RE: Lot 11 Block 4 Unit 22 SAD 228

6409 Canavio Rd. NW Volcano Cliffs Subdivision Grading and Drainage Plan

Engineers Stamp Date 1/25/2022 (D10D003D11) Building

G1

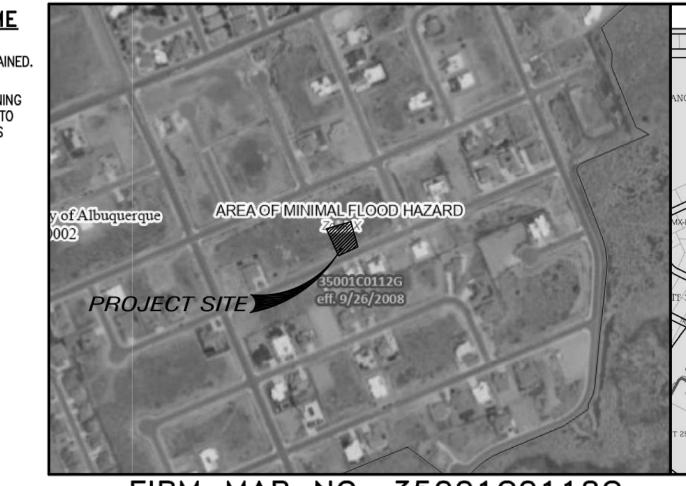
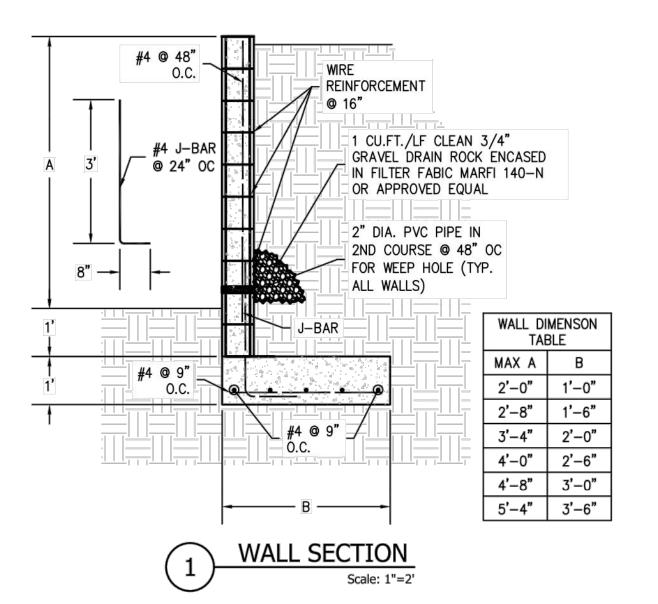
Prior to Building permit approval a Pad Certification will be required, provided by the

Advise the owner contractor not to use dirt as a ramp to climb the curb, use lumber or crusher fines for this purpose. Place this note on the plan.

Reiterate to the Owner/Contractor that a separate permit for a garden/retaining wall must be obtained with the approved G&D plan and Pad Certification. Also, if a swimming pool is to be placed after this approval a new grading and drainage plan will need to be resubmitted showing the changes for the land treatments.

Prior to Certificate of Occupancy release, Engineer Certification per the DPM checklist is required.
